GNH	Great Northern Highway - Muchea to Wubin Upgrade - Stage 2				
		Memorandum (MEM)			
MUCHEA TO WUBIN	Doc No.	GNH-CN12-EN01-LET-0001	Rev	1

Contract No. & Work Identifier:	CN12-EN01	Client Contract No.:	10/13	Date:	5/07/2018		
Contract Title:	Bindoon Bypass						
То:	Mark Jefferies						
Copies:	John Braid; Norm Fox						
From:	Lisa Boulden						
Subject:		Great Northern Highway Muchea to Wubin Upgrade – Stage 2: Bindoon Bypass (Assessment Number 2135) – Request for Change to Proposal

Current Development Envelope and Revised Alignment

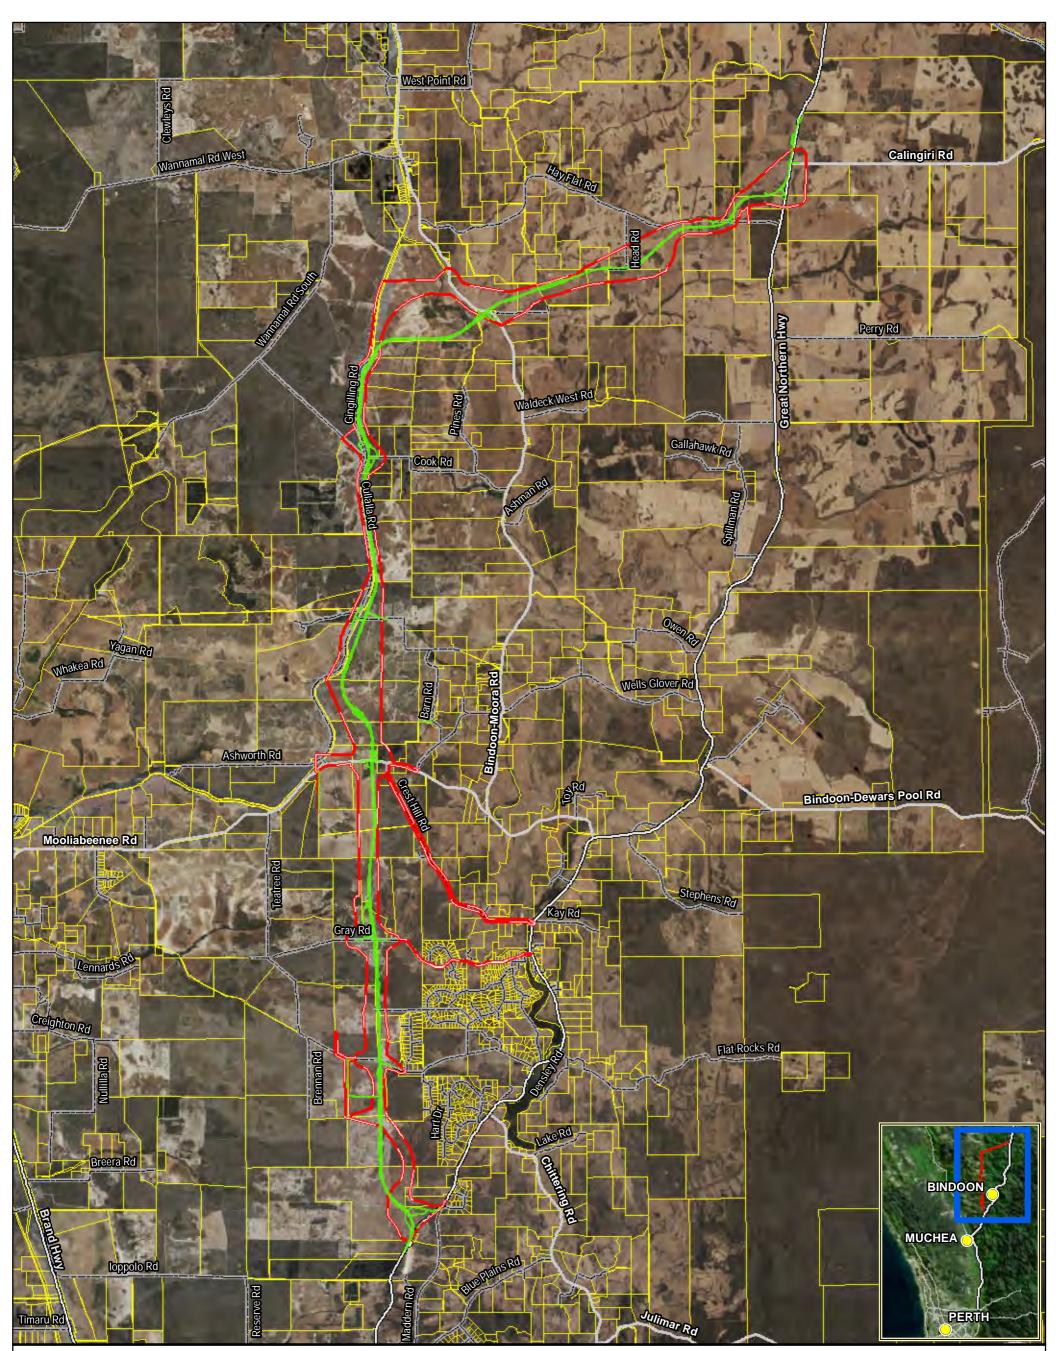
Figure 1 shows the current Development Envelope that was submitted with the referral and an overview of the revised road alignment. As noted above, there are six locations where the revised alignment now extends beyond the development envelope:

- Southern Chittering realignment
- Teatree Road
- Wannamal wetland
- Calingiri Road
- Local road to address loss of access to M1465 and M1364 Cullalla Rd, Mooliabeenee.

• Local road to address loss of access to Lot 37 Crest Hill Road, Mooliabeenee.

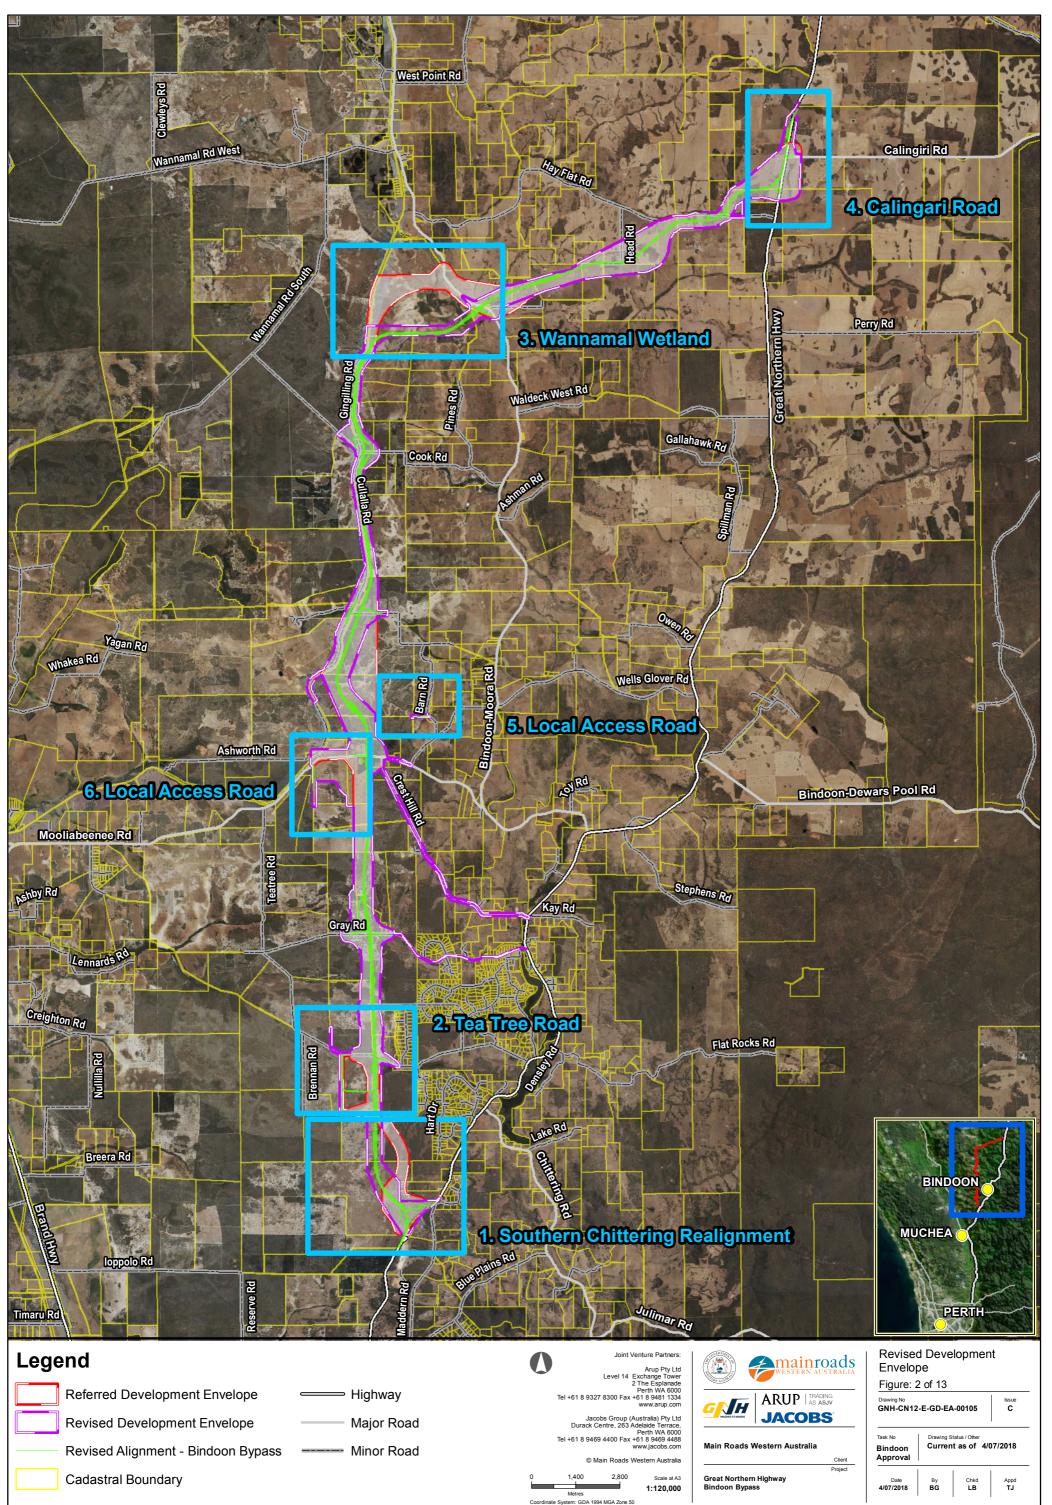
The revised alignment (**Figure 3**) results in improved road geometry and road safety by providing a longer straight, as well as allowing a shorter interchange structure at the southern tie-in. It also avoids impacting two properties additional properties (Lot 61 and Lot 62 Great Northern Highway, Chittering).

Figure 3 shows that the original alignment traverses through land with more consolidated remnant vegetation blocks, and a greater concentration of Black Cockatoo known nesting trees and potential breeding trees.

The original alignment would result in the clearing of one known nesting tree and four trees with hollows suitable for use by Black Cockatoos. The revised alignment avoids clearing of all known nesting trees, but will result in the clearing of two trees with hollows suitable for use by Black Cockatoos (**Table 2**).

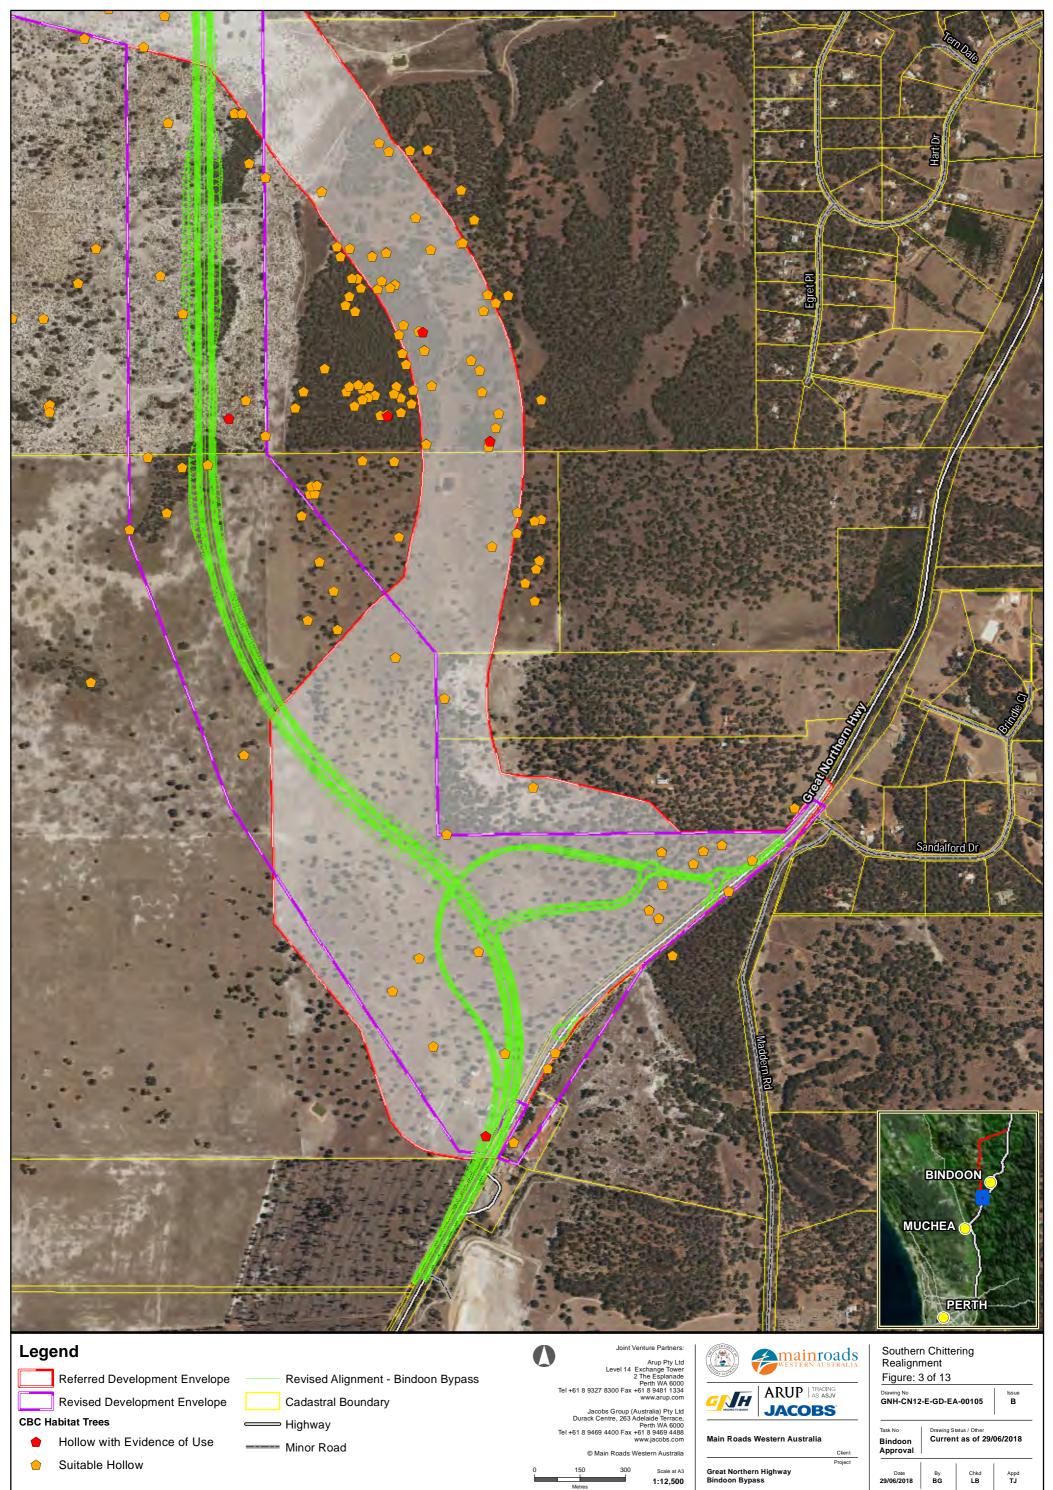
Conversations with the landowner following the initial design period found that moving the intersection to the north and approximately midway through the property represented a better outcome for the landowner, and would link in with future development plans for the property (**Figure 4**). The location of the intersection was selected to avoid areas of significant cut or fill, indicated by the white and red boxes on **Figure 4**, which would result in an unsafe intersection due to limited sight distance for vehicles at the intersection waiting to enter the highway. The revised location for the western Teatree Road intersection is at a neutral point between cut and fill, resulting in good sight distances for traffic entering the highway.

Lot 1 Teatree Road, Bindoon is mostly cleared. The proposed alignment for Teatree Road avoids a patch of "Very Good" condition Marri-Jarrah woodland and avoids all trees with hollows used by or suitable for Black Cockatoos (**Figure 4**). No Threatened or Priority flora have been recorded from this area and none of the vegetation has been identified as representative of a TEC or PEC. The original alignment for Teatree Road also traversed mostly cleared paddock, avoiding all trees with hollows used by or suitable for Black Cockatoos. There is no change in impacts for this location.

Wannam Options			nment
Figure: 5	5 of 13		
Drawing No GNH-CN12	-E-GD-EA	-00105	lssue C
Task No		atus / Other	
Task No Bindoon Approval		atus / Other t as of 29/	06/2018

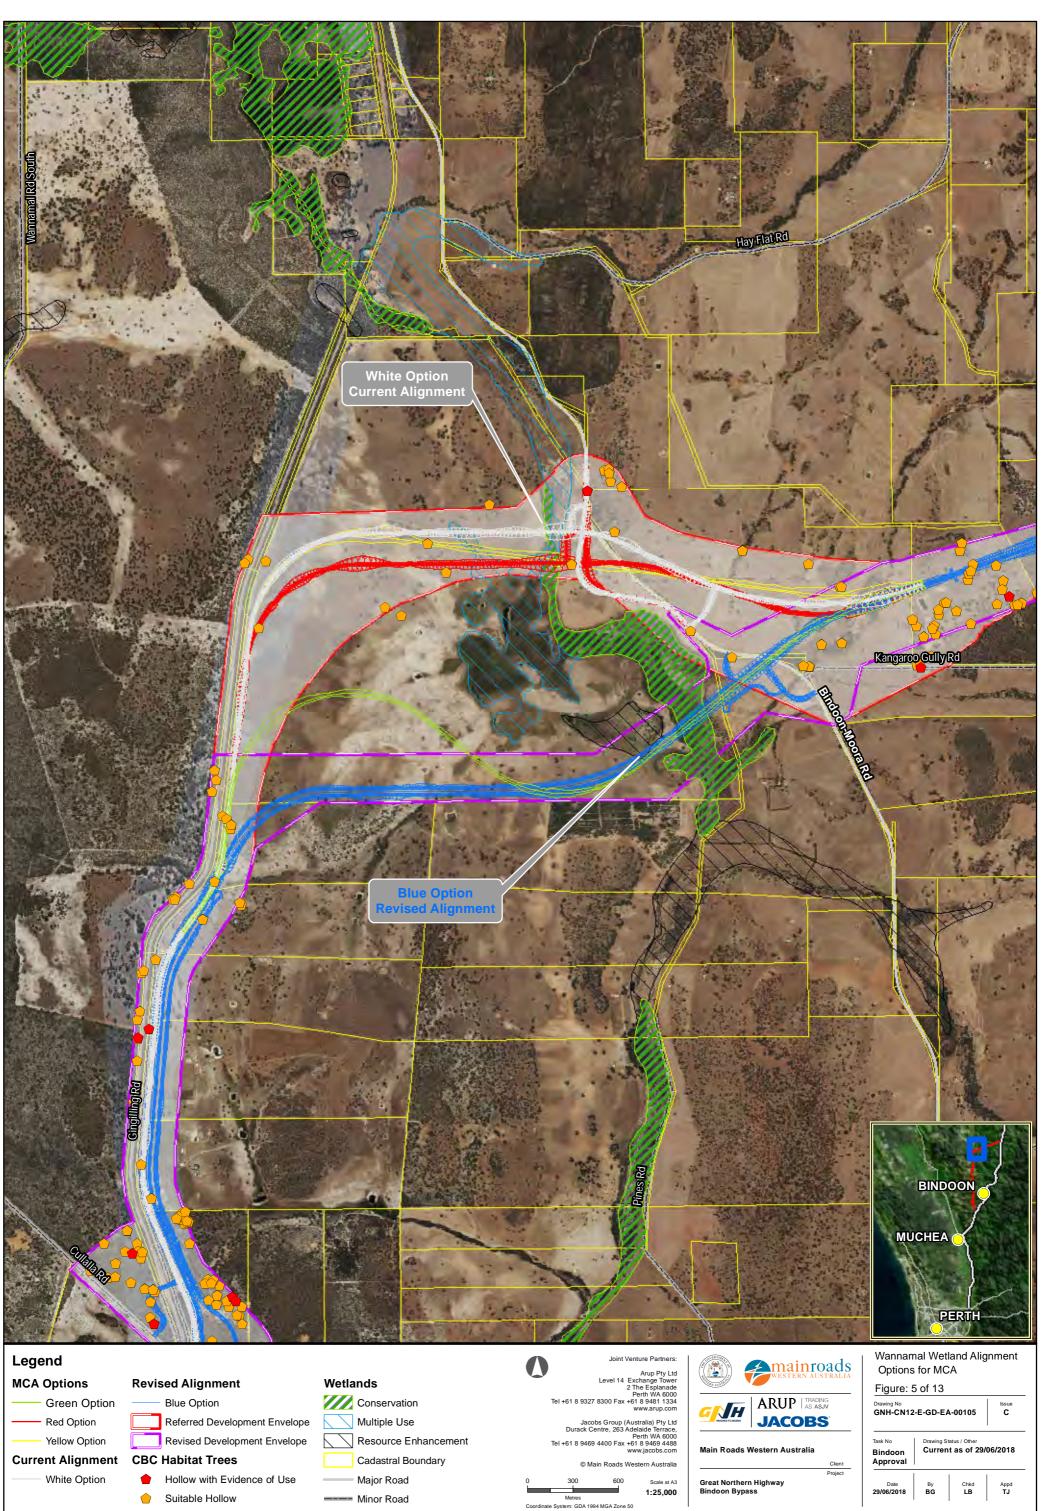
crossing the Brockman River at its narrowest point. This resulted in large cut and fill requirements, both in terms of length and height/depth, and a bridge height of approximately 13 m. This alignment also passed close to an occupied house (Lot 1 Bindoon-Moora Road, Wannamal) which would be isolated from the remainder of the property. The property would also be severed into two main portions, increasing the complexity of accessing the various portions of the property and ability to farm it as a single entity. The change to the proposed crossing point of the Brockman River is a result of consultations with affected landowners, which identified a number of concerns with the original alignment. A Multi Criteria Analysis (MCA) was undertaken to examine several alternative alignments (**Figure 5**):

- White option current alignment;
- Yellow option;
- Red option;
- Green option; and
- Blue option proposed alignment.

The MCA considered a range of social, environmental, engineering, constructability and economic factors, scoring each option against these factors to determine the best performing option. The result of the MCA was that the Blue option was the best performing of the five options considered. This option is generally supported by the affected landowners.

The Blue option traverses lower ground through cleared farmland. It will not require the same extent of cut and fill as the White option and requires a much lower bridge across the Brockman River. As a result, the Blue option has a lower construction cost. The Blue option also reduces severance impacts to Lot 1 Bindoon-Moora Road, Wannamal and reduces amenity impacts (noise and visual) when compared to the White option.

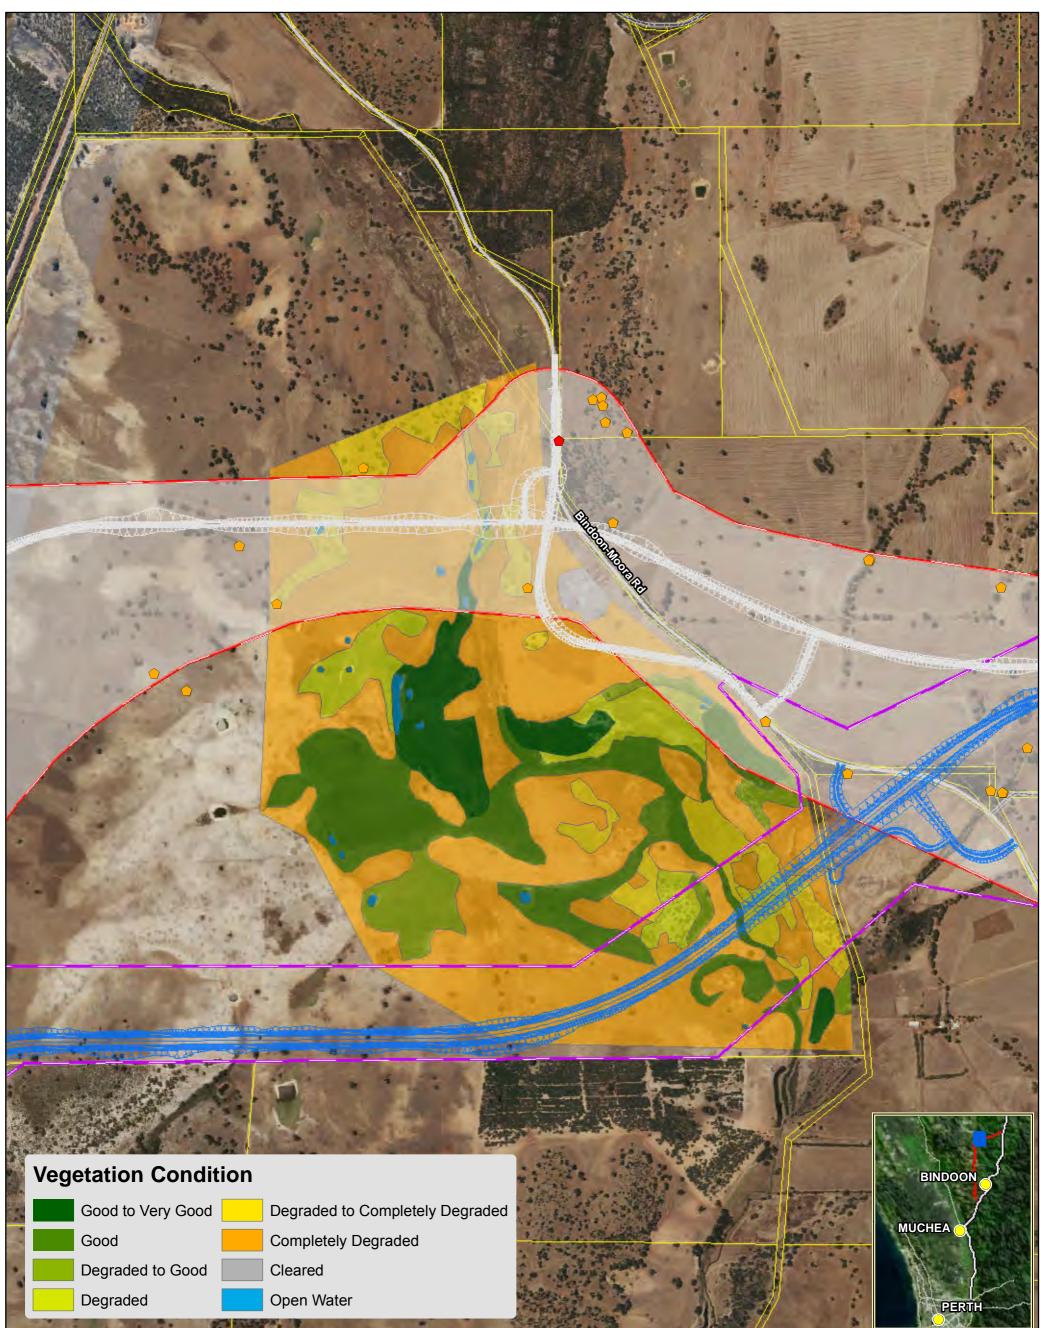
Ecological surveys undertaken in 2017 shows that the vegetation condition at the crossing point is mostly Degraded - Completely Degraded (D-CD) (**Figure 7**). It comprises cleared, summer grazing paddock with a fringe of retained paperback (*Melaleuca* sp.) remaining along the western margin. The current vegetation condition rating and land use (active grazing) appears at odds to the CC classification of this portion of the wetland.

Figure 8 : Approximate location of wetland crossing – Blue Option (photo taken 13 February 2018)

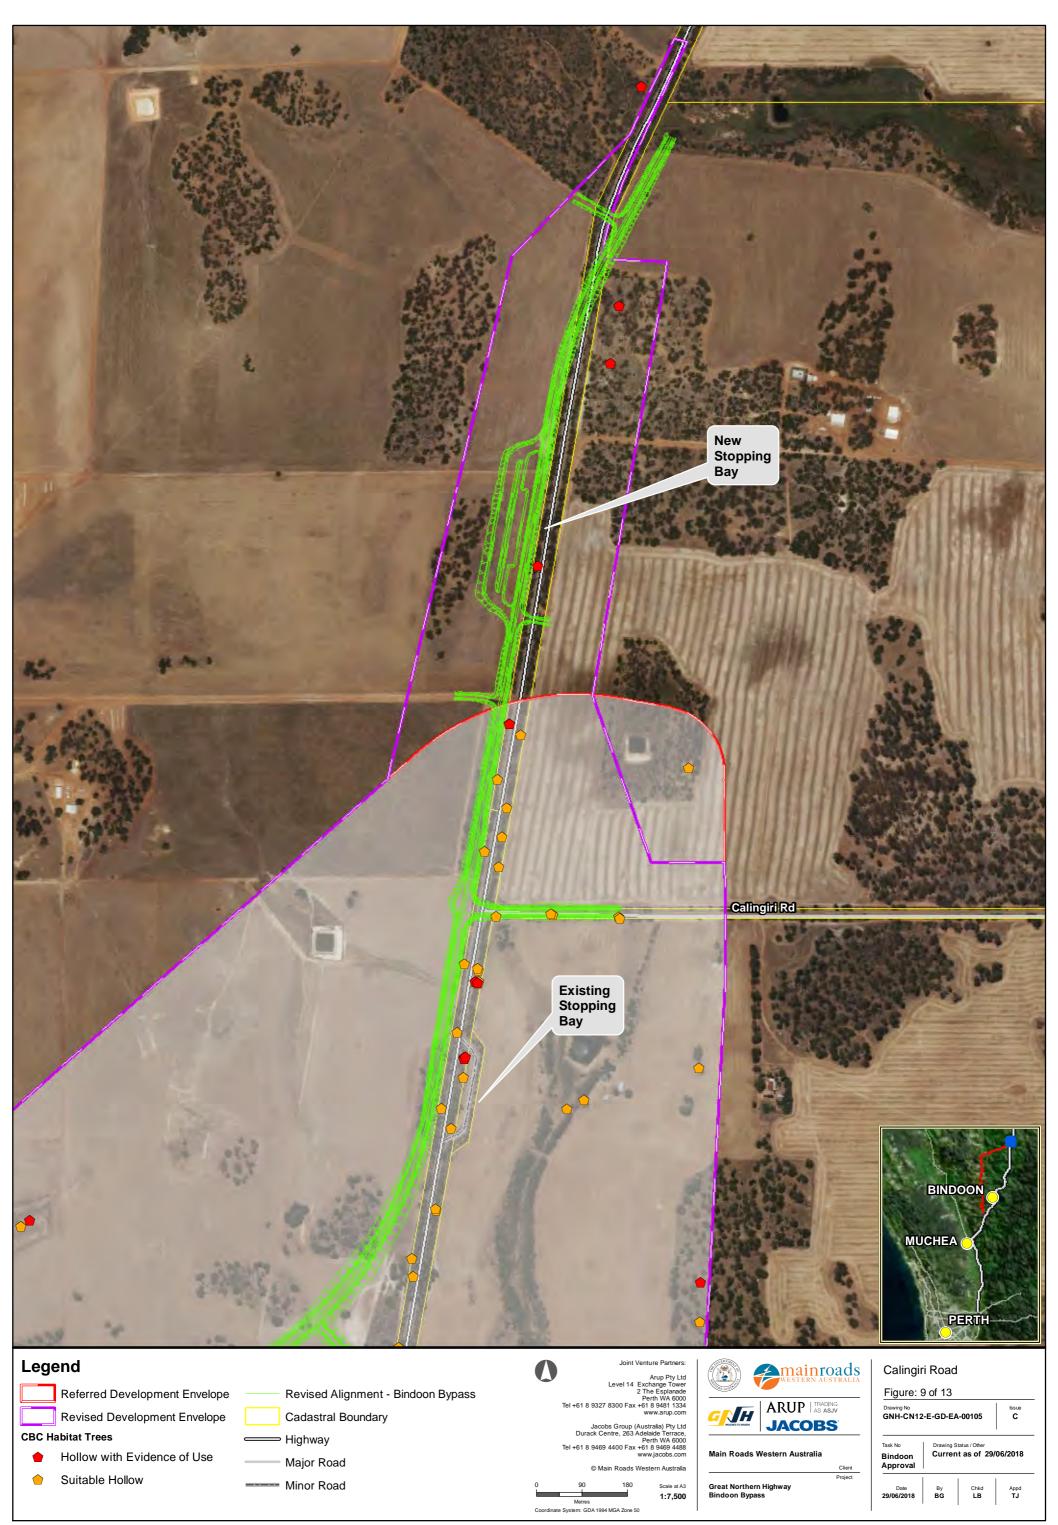
No additional significant impacts are anticipated due to the requested changes. An additional 0.2 ha of vegetation clearing will be required due to the extension of the Development Envelope at Calingiri Road, however this is counterbalanced by a 0.2 ha reduction in clearing due to the change in alignment at the Wannamal wetland area. Clearing within the defined boundary of CC wetlands will increase by approximately 1.1 ha, however the vegetation present within this wetland is mostly degraded to completely degraded as shown by **Figure 7** and **Figure 8**.
